Sunnica Energy Farm (EN010106)

Commentary on Communications between Natural England and Sunnica Ltd

Natural England ALC mapping request for clarification regarding ALC Grade mapping discrepancies (10/10/2022)

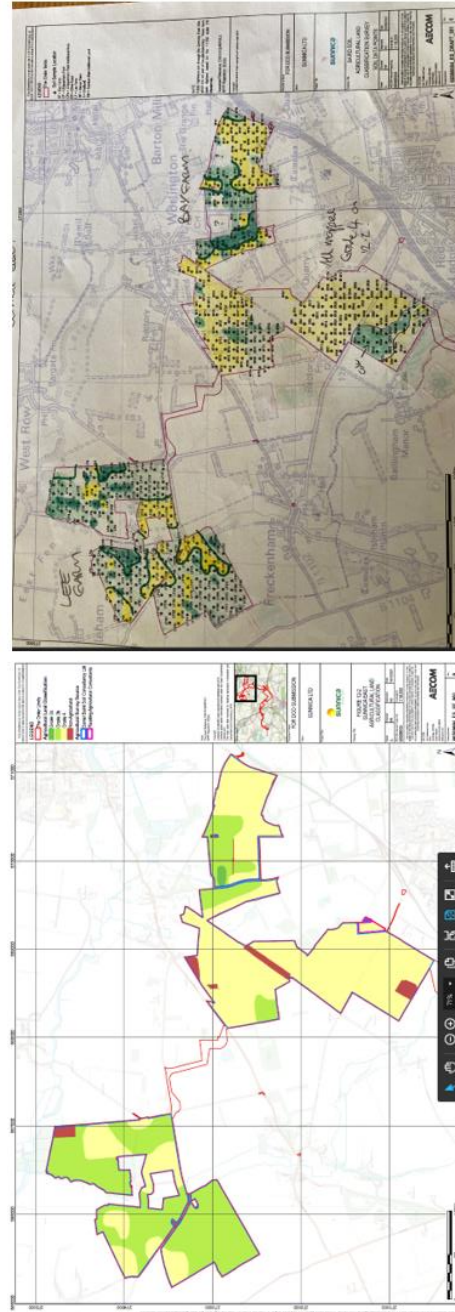
Comparison of Figure 12-2 and the roughly mapped ALC Grades according to the auger bore data provided in Appendix 12B. The attached photo above assumes the ALC Grades provided in Appendix 12B are correct.

There are areas of ALC grades which have been identified in the field by Daniel Baird (Appendix 12B), but not mapped accordingly in Figure 12-2.

Two areas of no ALC data marked by the question marks in the photo (Bay Farm). In figure 12-2, this unsurveyed land is graded a mix of ALC Grade 3a, 3b and 4. How was this grading determined? Would this land be subject to ALC survey prior to construction?

Lee Farm (Sunnica East): an area of Subgrade 3a is not mapped (points LF45, LF60, LF78, LF77, LF89, LF90, LF91, LF102).

Bay Farm (Sunnica East): an area of Subgrade 3a is not mapped (points BF18, BF35, BF54, BF55, BF72, BF87, BF89)

Elms Road (Sunnica East): an area of Subgrade 3a is not mapped (Points ER47, ER48, ER55, ER56, ER63, ER64, ER65, ER73, ER74, ER75, ER85, ER90, ER91)

Likewise, areas of Grade 4 have not been mapped (Lee Farm)

The borehole data should be reviewed and the ALC Mapping across the full site updated where appropriate. If there is a reason why these areas (or any other areas of discrepancy between the ALC grade mapped and the borehole data) have not been mapped, justification needs to be provided.

If the ALC Figures are updated, the areas of each ALC grade should also be updated in the Environmental Statement and ALC Report.
